Remedial Measures Verification Report

Calder View, Lower Hopton

48808-ECE-XX-XX-CO-C-0004
KE/JB

We write in response to Kirklees Council's Environmental Health Consultation Response dated 30 September 2024. The queries in the Consultation Response are addressed below.

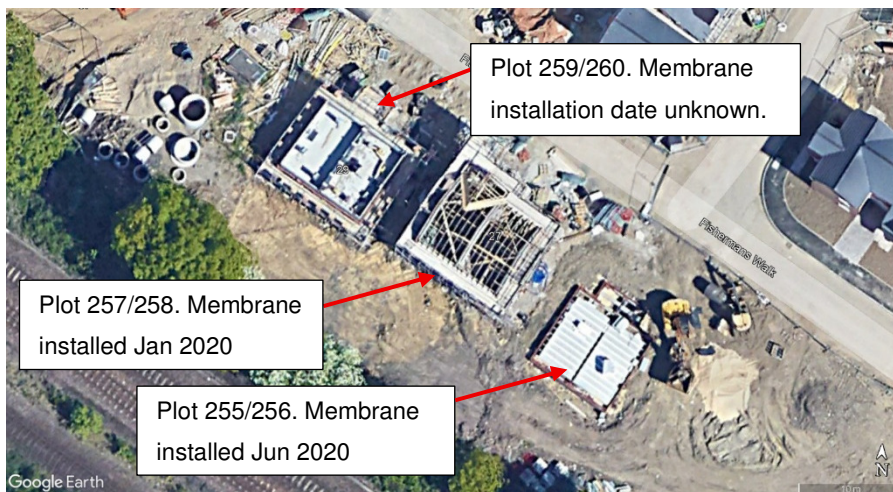
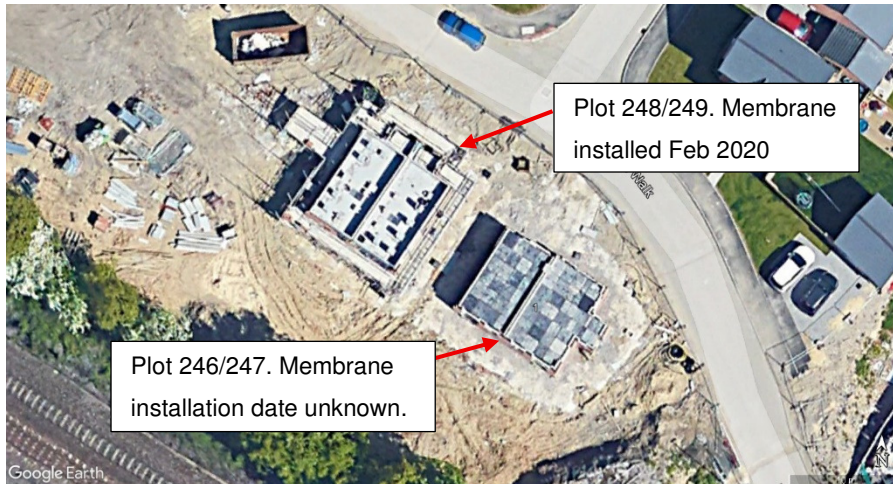
Gas protection documents have been reviewed and we are satisfied with the information provided but information is missing for the following plots 205-208, 232-234, 247, 260, 280.

A number of plots across the site were not verified as part of ASL's validation reports and ECE have not been provided with a record of the installations:

- Plot 241 – see below discussion;
- Plots 246/247 & 259/260 – Plots 247 and 260 are listed in the title of ASL's 2020 report but there is no associated Prestige installation record for these plots, or their adjoining plots;
- Plots 265-267;
- Plot 280 - listed in the title of ASL's 2020 report but there is no associated Prestige installation record for this plot. See below discussion.

Publicly available satellite imagery dated April 2020 taken during construction shows a black membrane installed across Plots 241 and 280 as shown on the below image:

Plot 246/247 and Plots 259/260 are understood to have been constructed at a similar time as Plots 248/249 and 255 to 258, as shown on the below satellite images, dated April 2020. It is likely that the gas protective measures for these plots would have been installed at the same time.

This membrane appears so be similar to the Juta GP1 installed on other plots.

Although the installation records are not a complete set, we do not expect this is due to a lack of gas measures being installed but instead, incomplete records being kept. Aerial photography has shown two plots to have a membrane which appears to be the Juta GP1 installed even though we have not seen a corresponding installation record. It is likely to be the same situation on other plots where no installation records are available.
